INSTRUMENT: 5004A Signature Analyzer
Operating and Service Manual

SERIAL PREFIX: 1704A

CHANGE DATE April 15, 1977

FIGURE 1. FLOWCHART CORRECTIONS

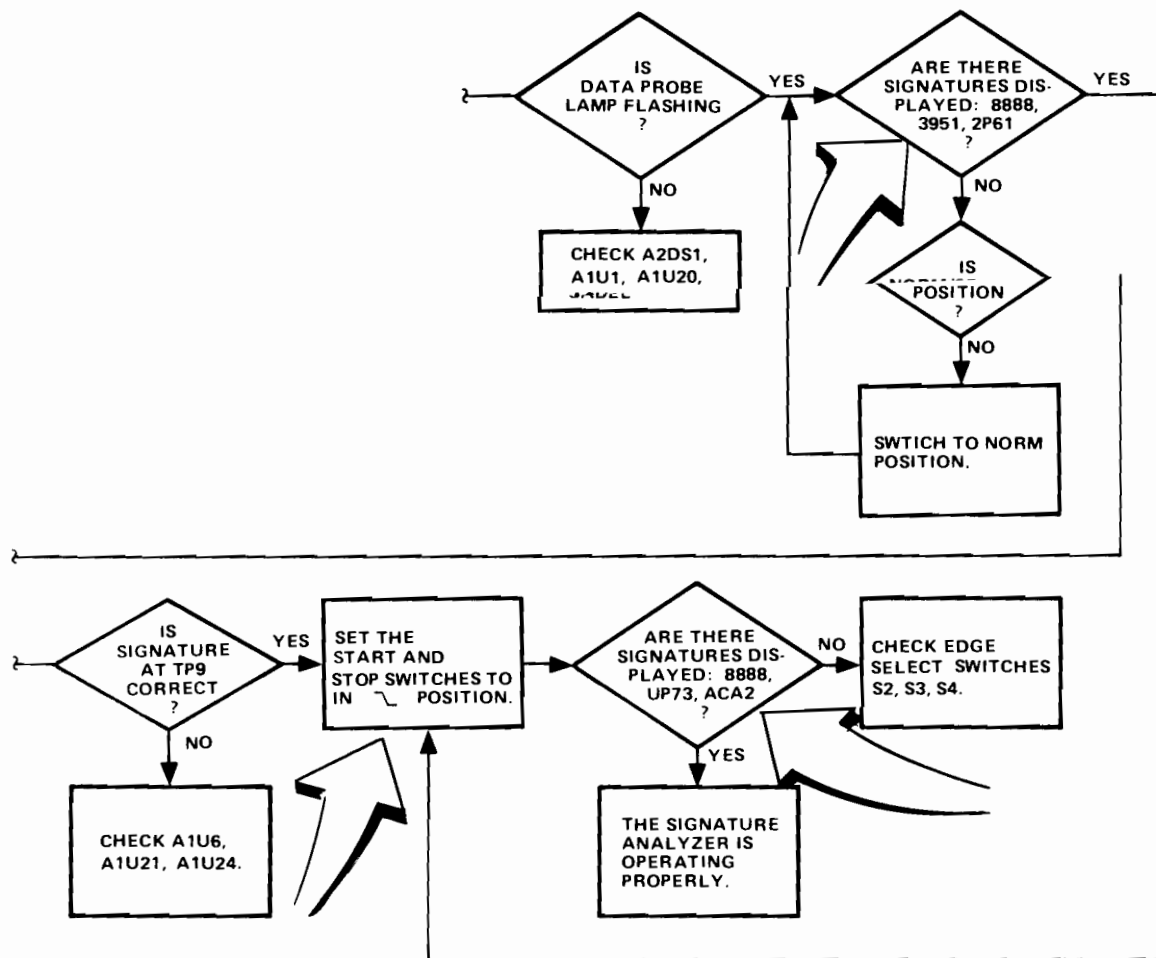
► Page 8-11, Figure 8-1, Troubleshooting Flowchart:

Change step 1 of "PRELIMINARY STEPS" to the following:

"1. SET FRONT-PANEL SWITCHES AS FOLLOWS: SELF-TEST-IN; START, STOP, CLOCK, AND HOLD-OUT."

Change flow chart in three places to agree with the partial diagram shown in Figure 1.
